Re: 870 Mill Creek Road, Arnold
Tax Map 32, Block 17, Parcel 4
Permit G02020213, Prefile 2025-0017-P
Letter of Explanation- variance application

VARIANCE/GRADING & SEDIMENT CONTROL PLAN

870 MILL CREEK ROAD
 TAX MAP 32 BLOCK 17, PARCEL 4
 ZONED R5

OFFICE OF PLANNING AND ZONING

GRADING/SWM PLAN

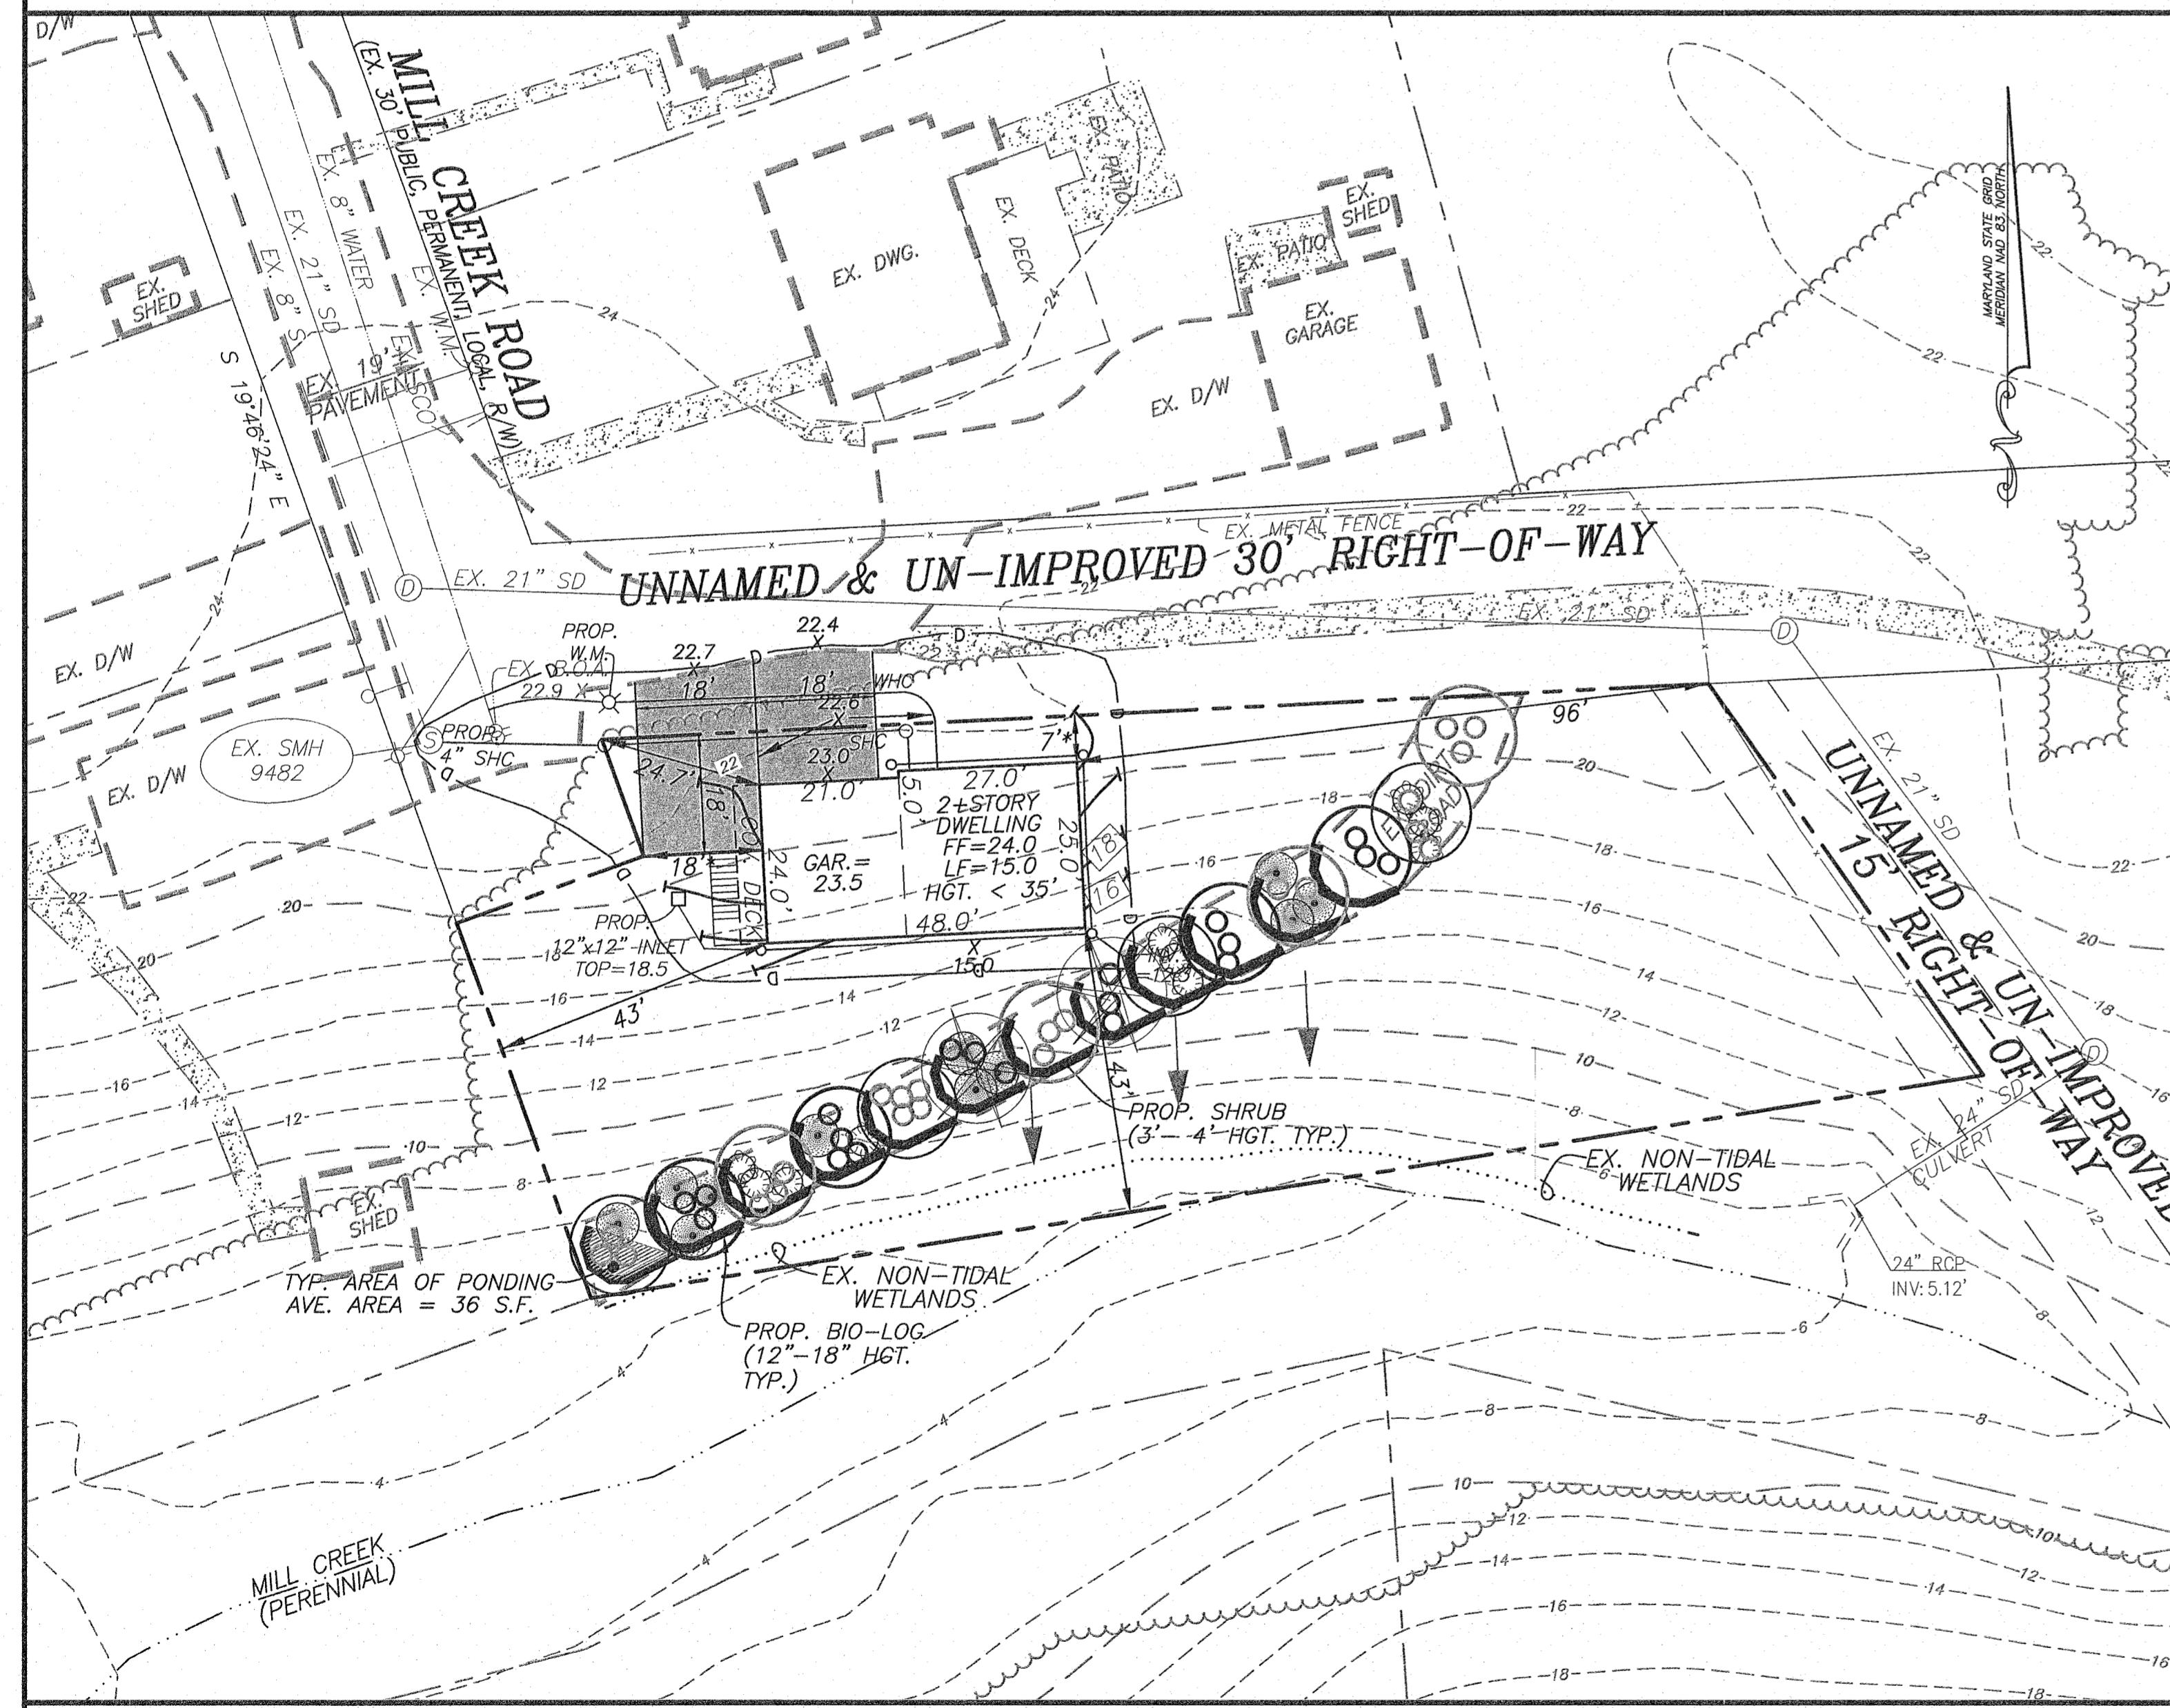
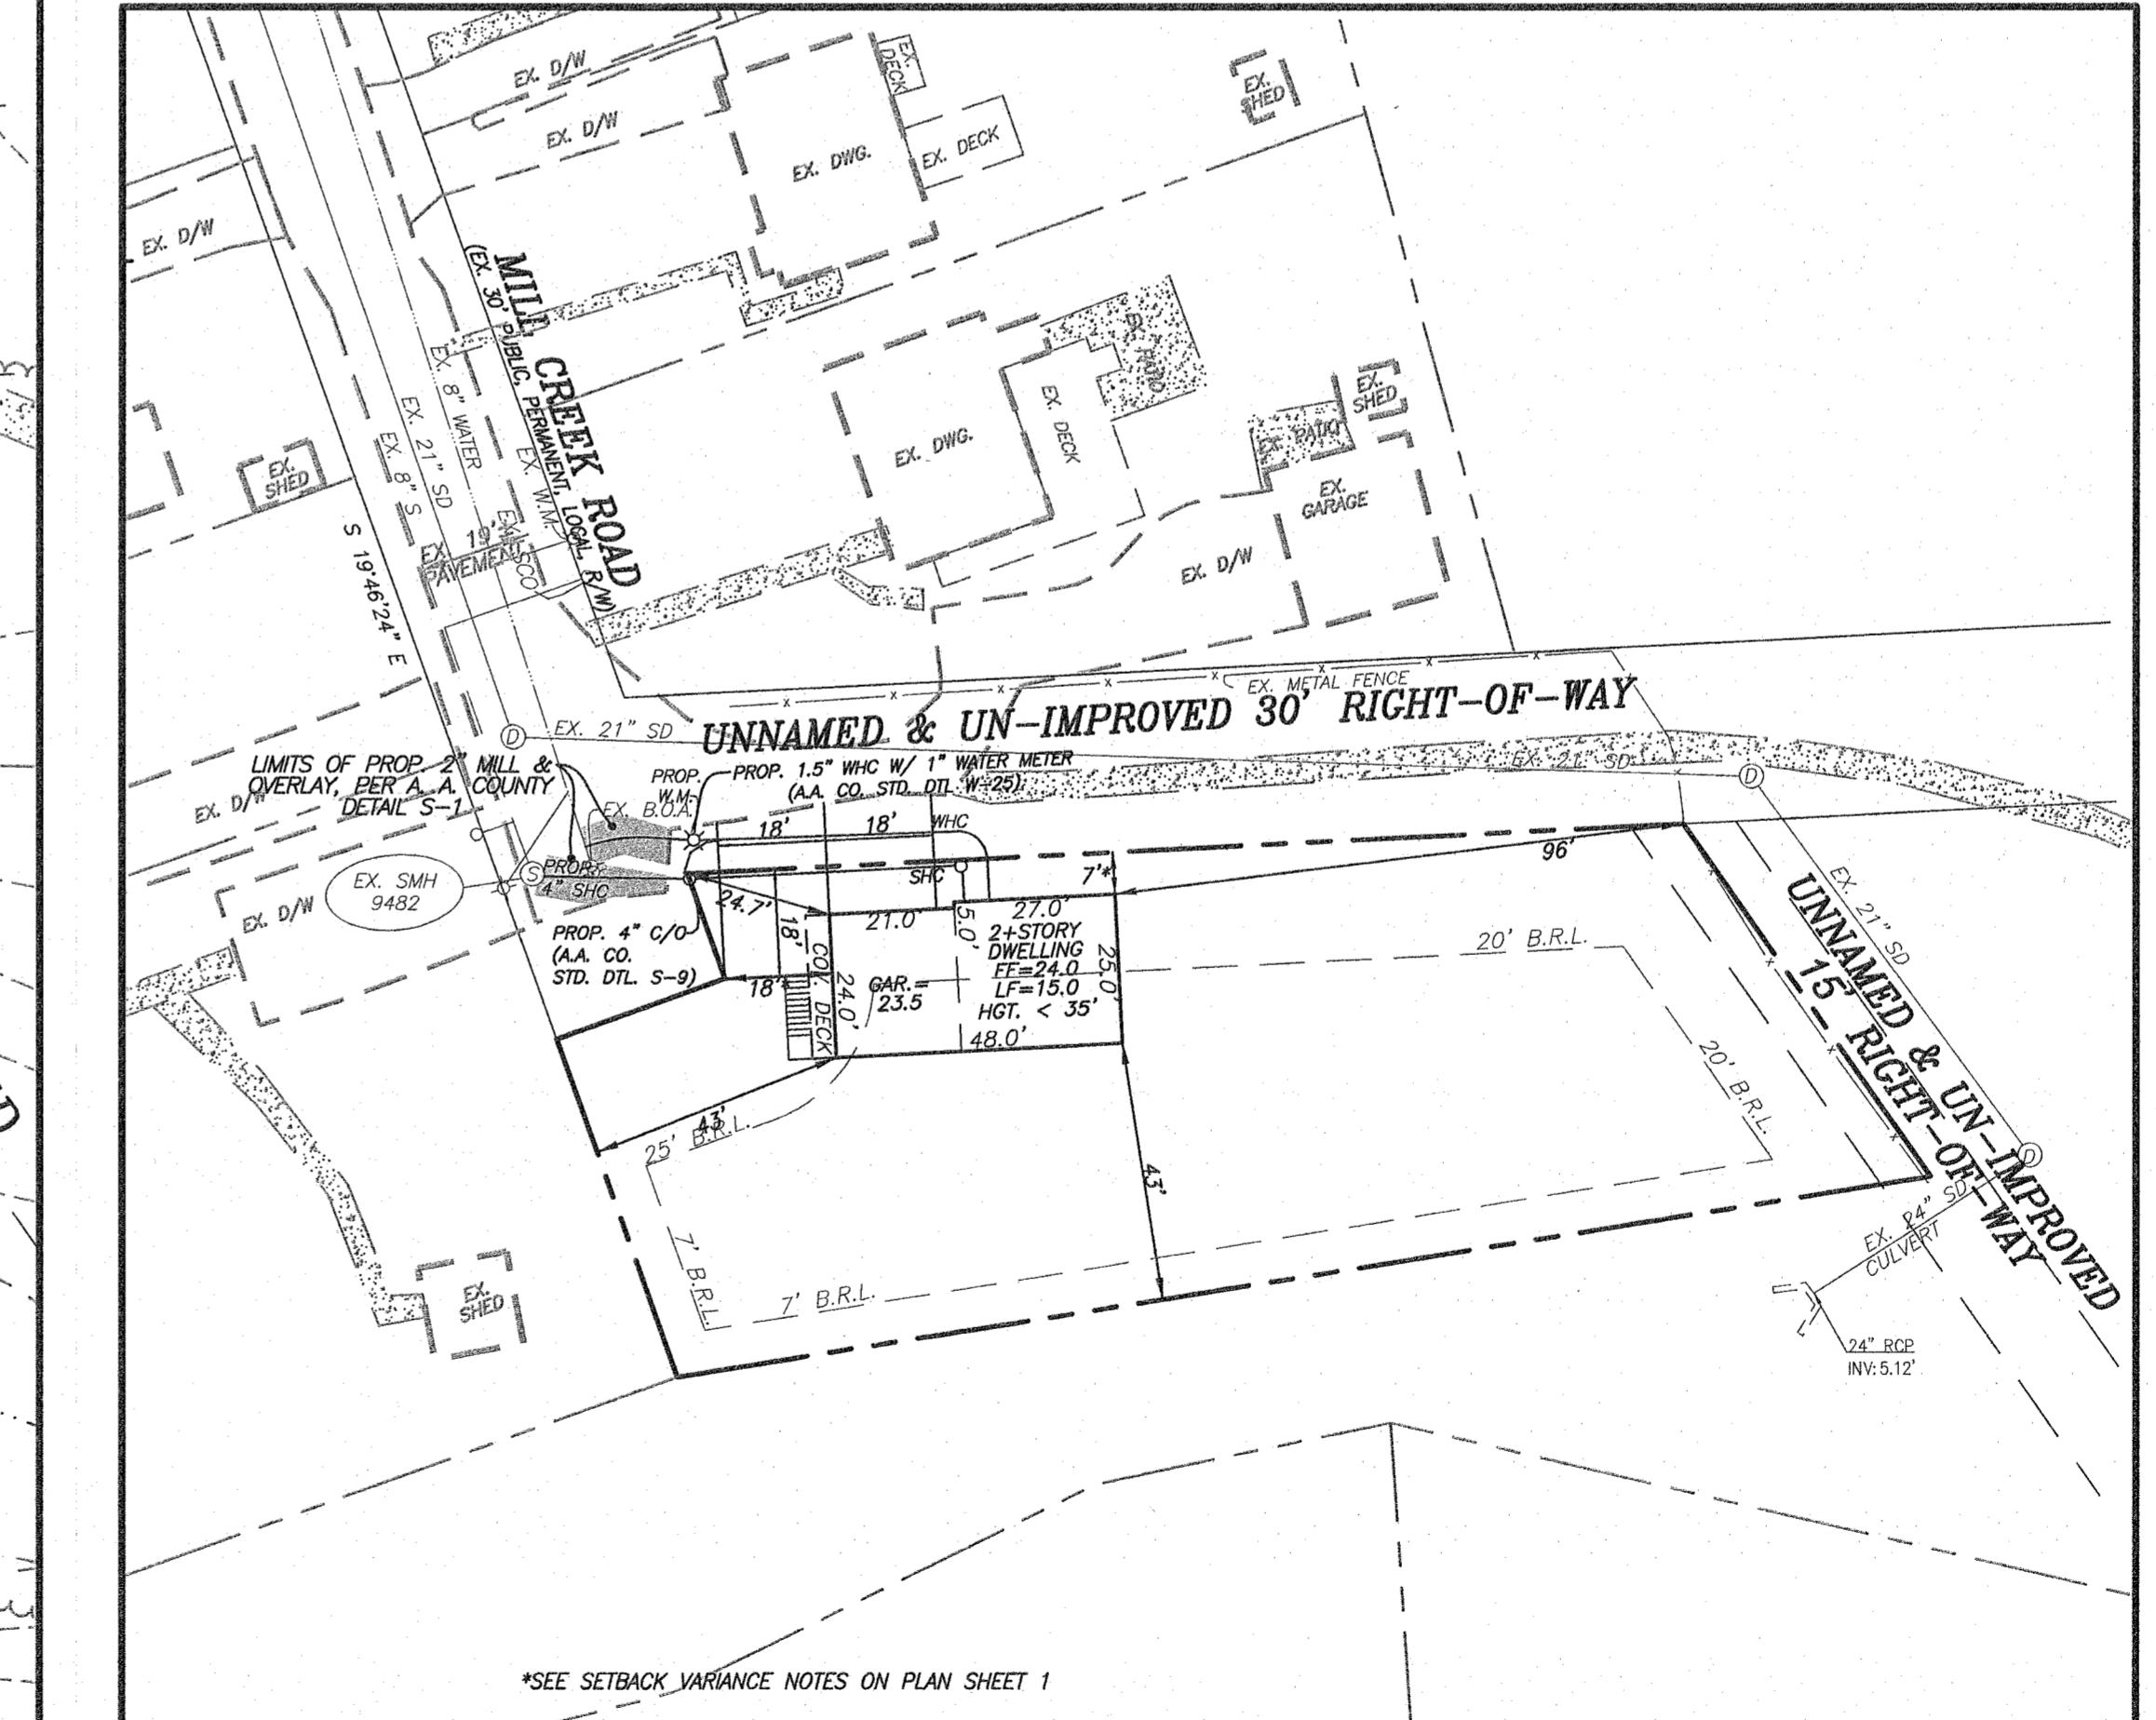
Revise the Administrative Site Plan to clearly indicate the setback distances to all lot lines in order to verify the relief requested.

In addition, it appears that the grades for the driveway have been mislabeled and there is concern for the grade of the actual driveway as well as the grading around the driveway and the ability for the applicant to cut back into the existing grades as shown on the plan. Without the opportunity to read the statements in the prior decision, I do not believe that this proposal meets a reduction in impact.

1. It appears the Sewer House Connection ties into the existing sewer along Mill Creek Road. Show the existing manhole where the connection occurs. Label the manhole number. If no manhole exists, a proposed manhole will need to be installed and will require a PWA. Address at grading permit.

2. If the public waterline ends with a fire hydrant, show and label the fire hydrant including its number. Show the tie-in for the WHC prior to the terminal fire hydrant. Address at grading permit.
